SUPPLEMENT I
to the
1979 SAFETY ANALYSIS REPORT

Nuclear Science Center Reactor
Texas A&M University System

30 March 1982

III. CLARIFICATIONS AND CHANGES TO THE 1979 SAR

FIGURE 5
EQUILIBRIUM HYDROGEN PRESSURE OVER $ZrH_{1.65}$ vs TEMPERATURE
(FROM FIGURE 2-9, REF 3)

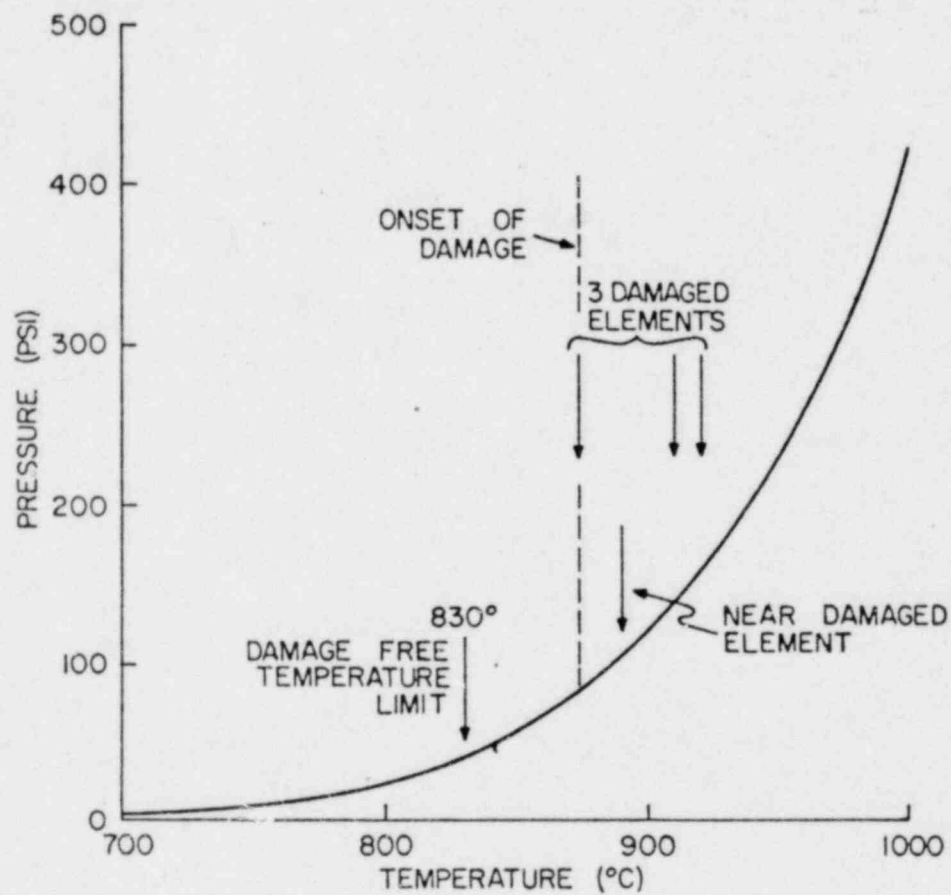
To determine a damage-free temperature limit for pulsing notice the arrows on Figure 5 which mark the calculated peak temperatures experienced by the damaged elements. The dashed line at 874°C is defined as the onset of damage since this is the lowest temperature observed for a damaged element and the near damaged element was calculated to reach temperatures 16°C higher. A factor of 2 reduction in equilibrium pressure from this value is considered a reasonable and prudent safety factor. This establishes a limit of 830°C for pulsing in a core that has had greater than 8 Mw-days of steady state burnup. The proposed Technical Specification is:

Specification: The reactivity to be inserted for pulse operation shall not exceed that amount which will produce a peak fuel temperature of 830°C . In the pulse mode the pulse rod will be limited by mechanical means so that the reactivity insertion will not inadvertently exceed the maximum value.

FIGURE 3-6 CONTROL ROD BUNDLE WITH GUIDE TUBE

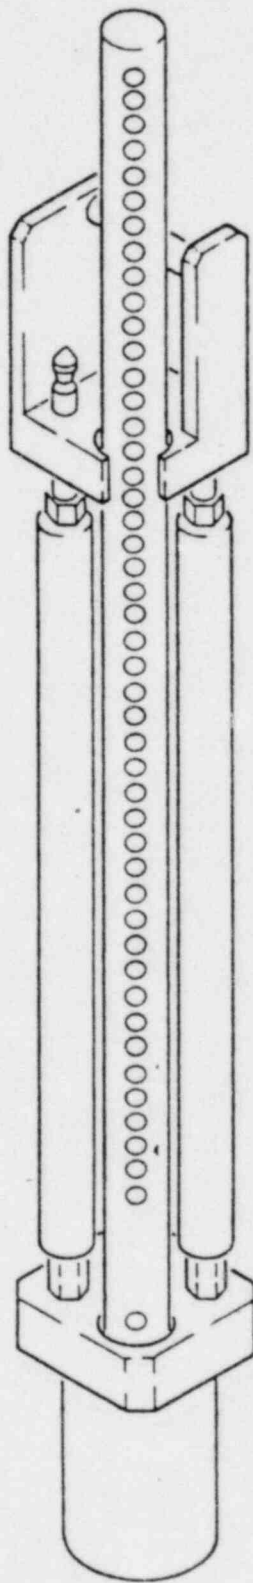
Figure 3-6 - This figure has been changed from a photograph to a drawing to improve reproduction and clarity.

FIGURE 3-24 PEAK POWER VERSUS FULL WIDTH AT HALF PEAK POWER-PROTOTYPE REACTOR

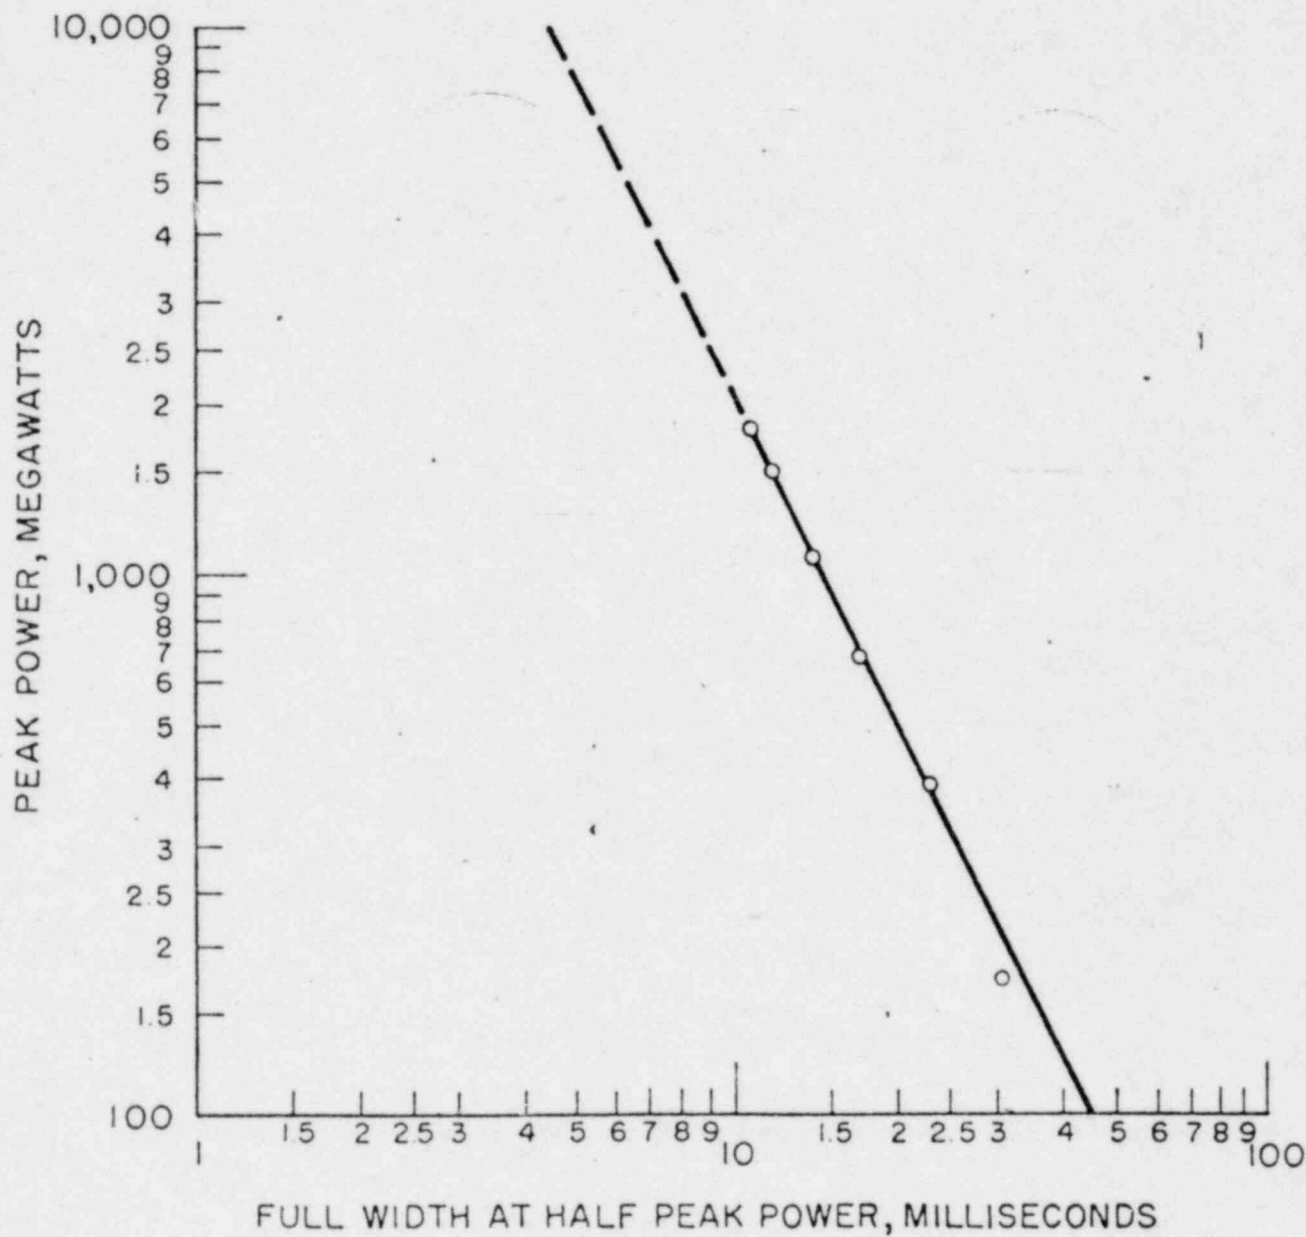
Figure 3-24 - The "Full Width at Half Peak Power" Scale has been corrected.

FIGURE 9-1 RADIOACTIVE LIQUID WASTE DISPOSAL SYSTEM

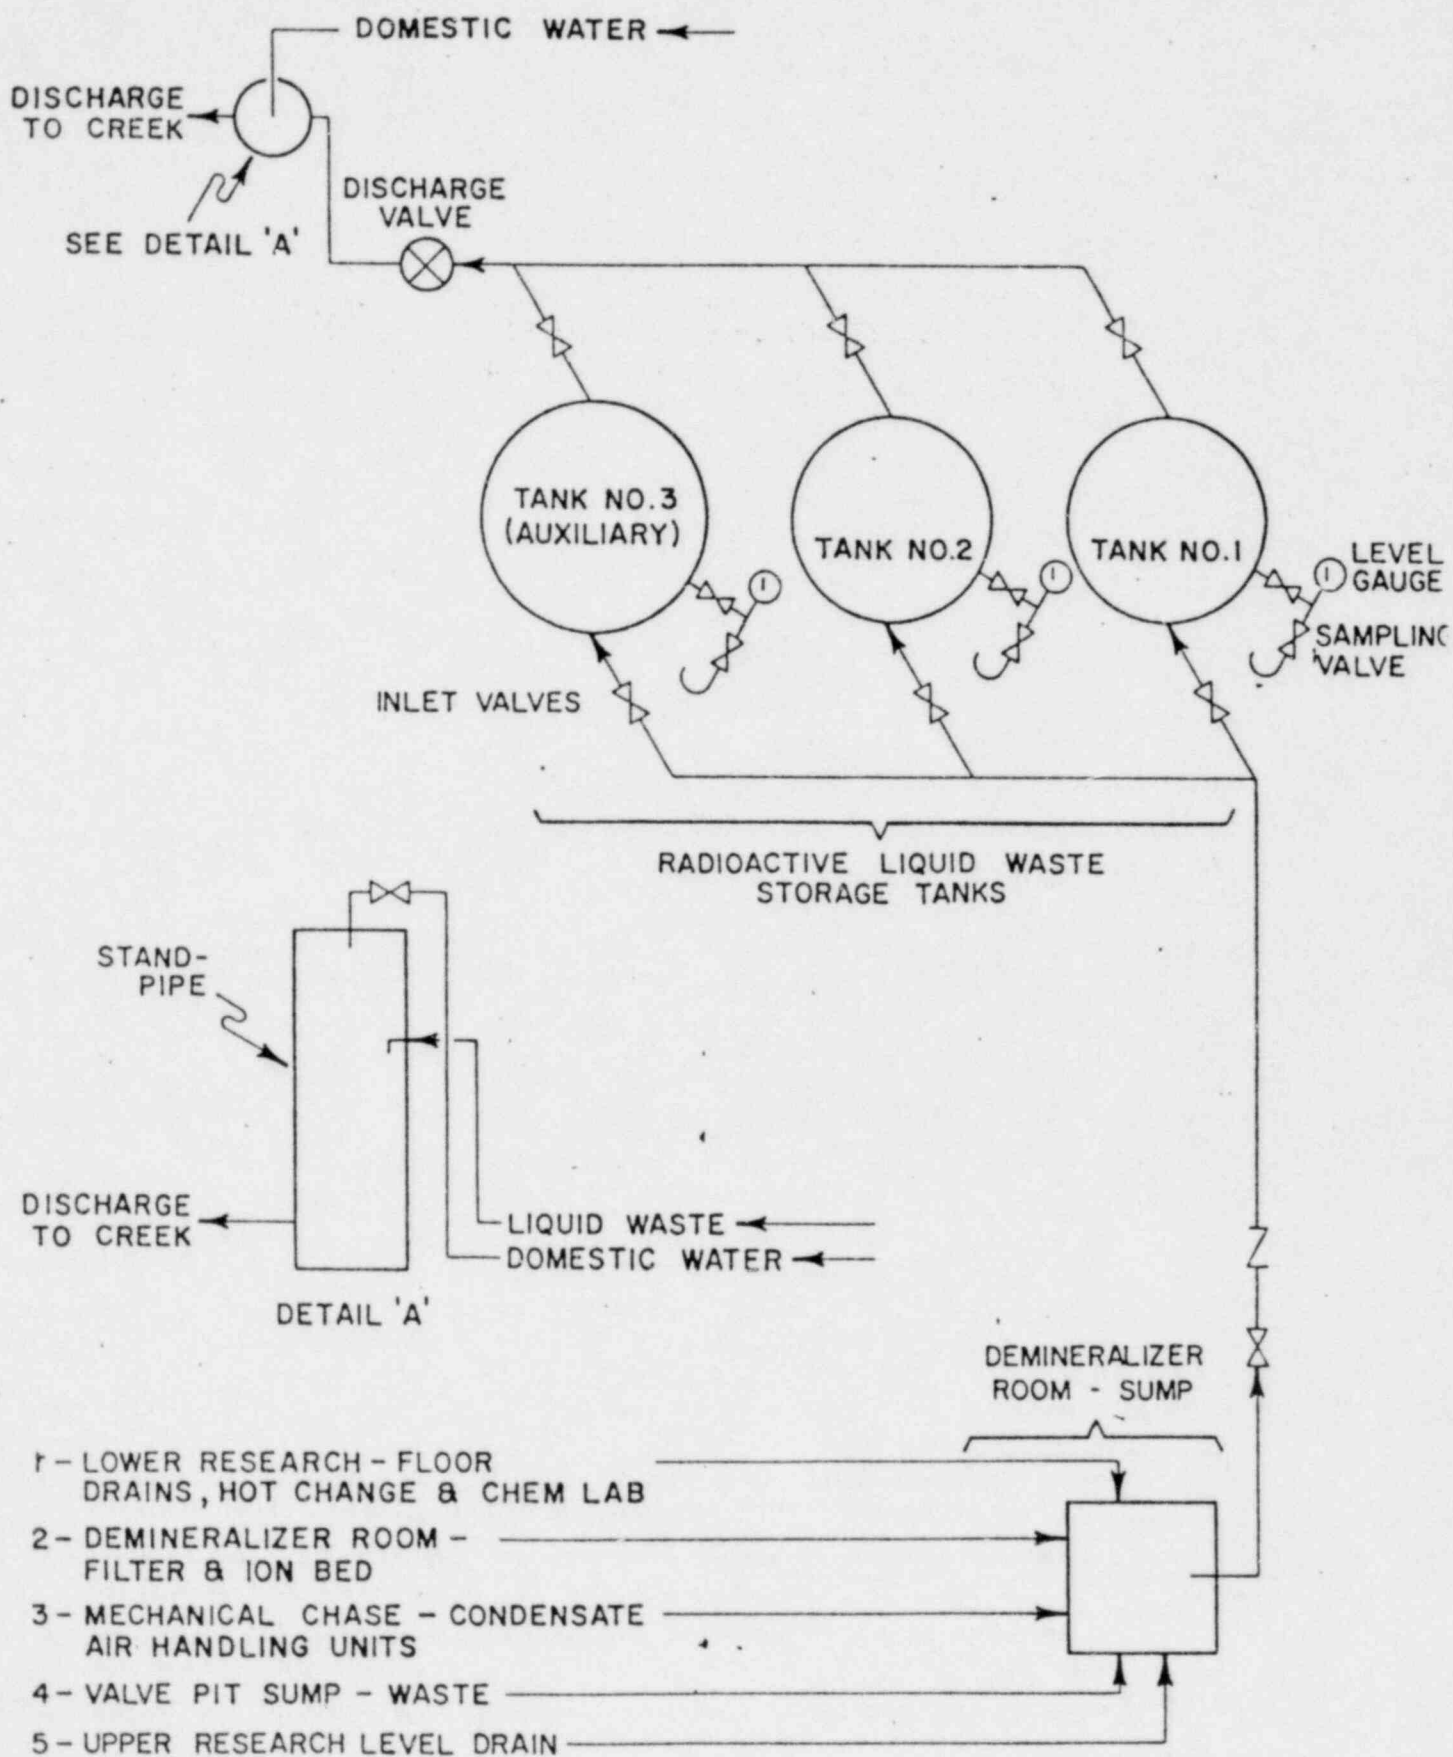
Figure 9-1 - A revised drawing of the "Radioactive Liquid Waste Disposal System" is submitted

FIGURE 9-2 FACILITY AIR MONITORING SYSTEM

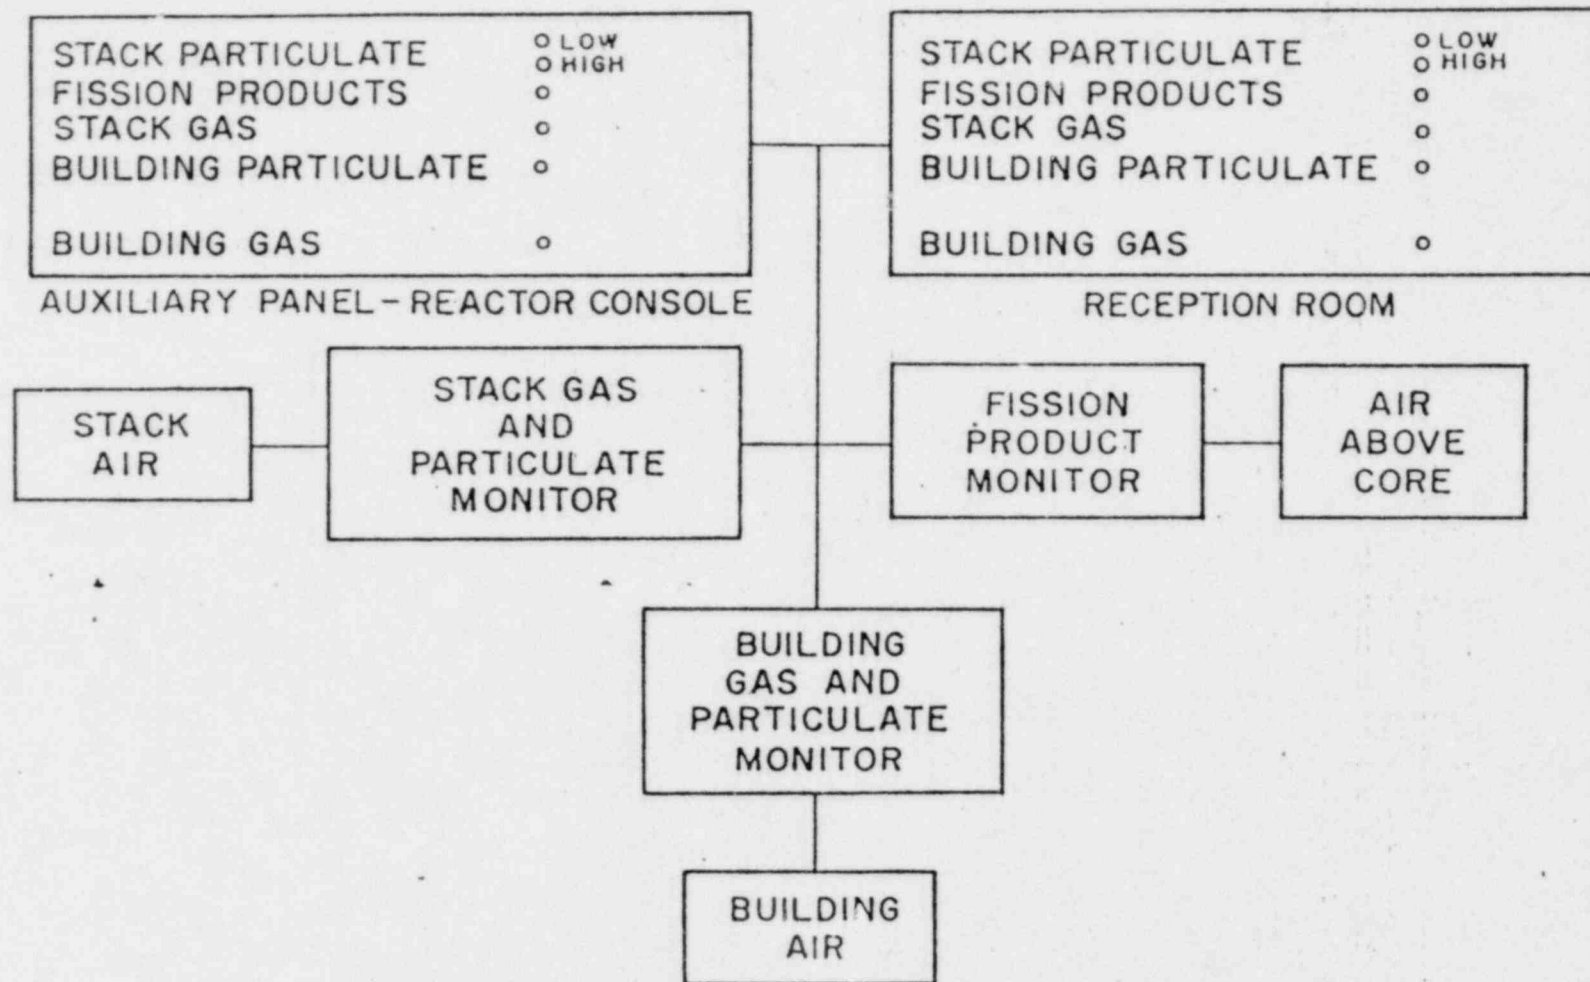
Figure 9-2 - Remove the following air monitoring system:

"Delayed Particulate ACT".

FIGURE 3 DECAY HEAT POWER GENERATION FOLLOWING LOSS OF COOLANT FOR INFINITE REACTOR OPERATION AND PERIODIC REACTOR OPERATION

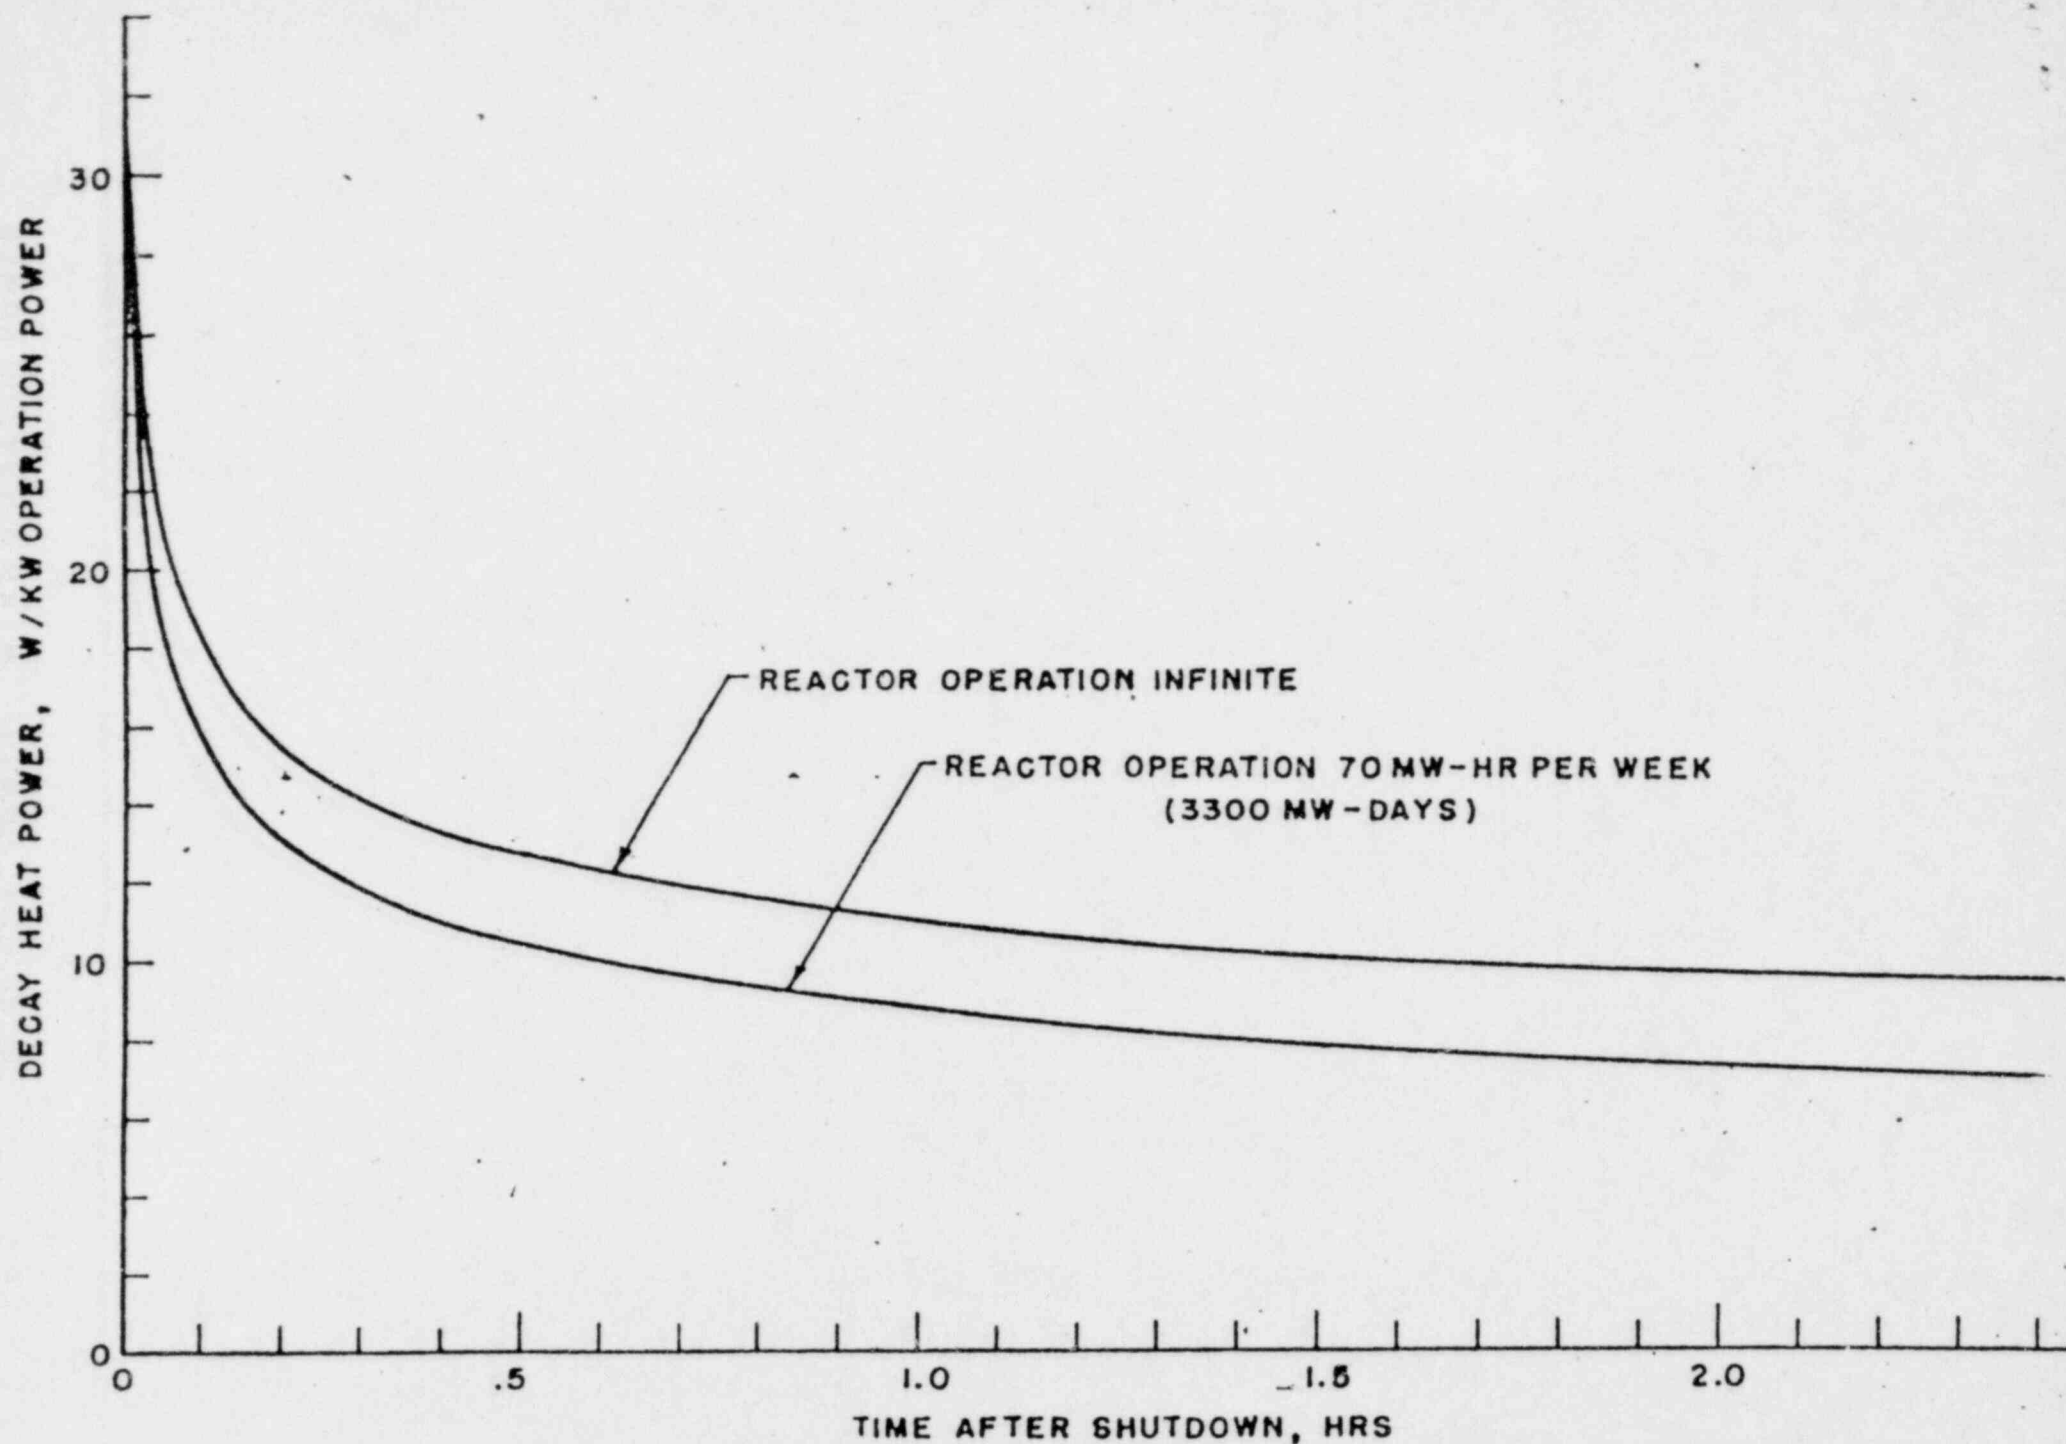
Figure 3, Appendix II - The ordinate scale on Figure 3 has been corrected to read:

"DECAY HEAT POWER, Watts/Kw OPERATION POWER"
